UNITED STATES PATENT AND TRADEMARK OFFICE

| APPLICATION NO. | FILING DATE | FIRST NAMED INVENTOR | ATTORNEY DOCKET NO. | CONFIRMATION NO. |
|-----------------|-------------|----------------------|---------------------|------------------|
| 10/815,565 | 03/31/2004 | Daewoong Suh | 884.C14US1 | 7135 |

Office Action Summary

DETAILED ACTION

**FIG. 4**

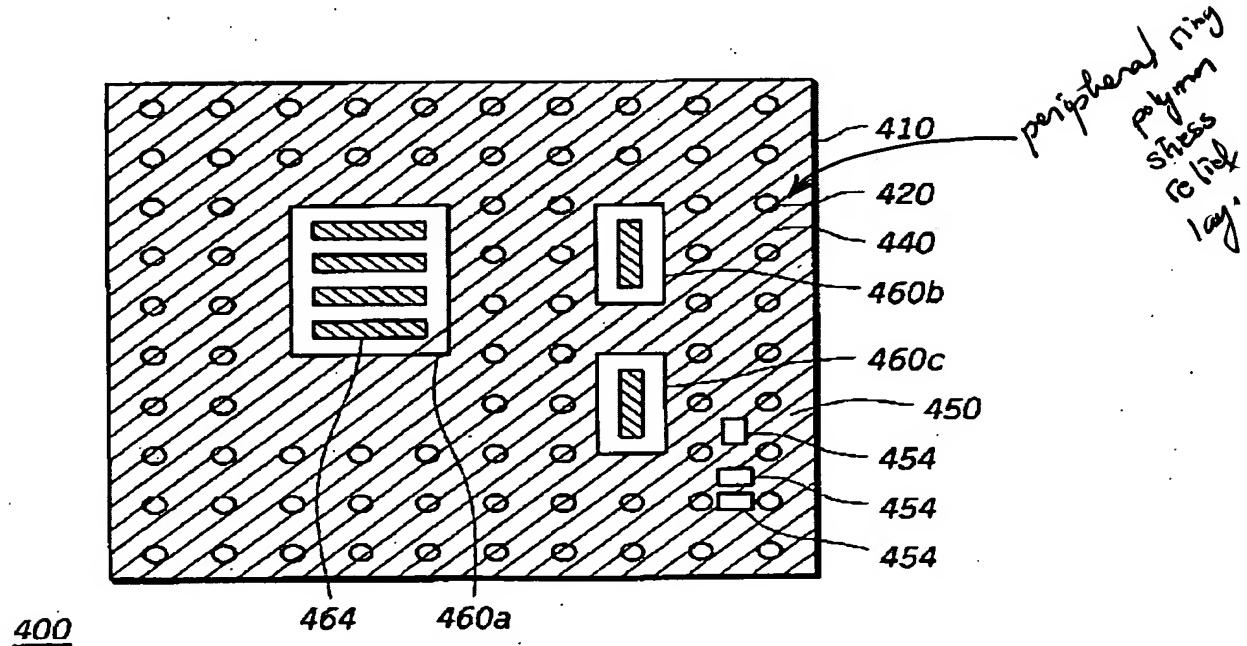
locating an electrical first bump (420, fig 4) upon a substrate lower surface, wherein the electrical first bump touches a peripheral ring polymer stress-relief layer (portion of polymer stress-relief layer 440 located in a region between the outer loop of bumps 420 and edges of the chip 410, see fig 4 of as attachment for details)

► In regard to Applicant's argument on page 8 that Vanfletern et al does nothing to teach "peripheral ring polymer stress relief layer, argument is not persuasive since Chason et al teaches the a peripheral ring polymer stress relief layer (440, see fig 4 below). In response to applicant's arguments against the references individually, one cannot show nonobviousness by attacking references individually where the rejections are based on combinations of references. See *In re Keller*, 642 F.2d 413, 208 USPQ 871 (CCPA 1981); *In re Merck & Co.*, 800 F.2d 1091, 231 USPQ 375 (Fed. Cir. 1986).
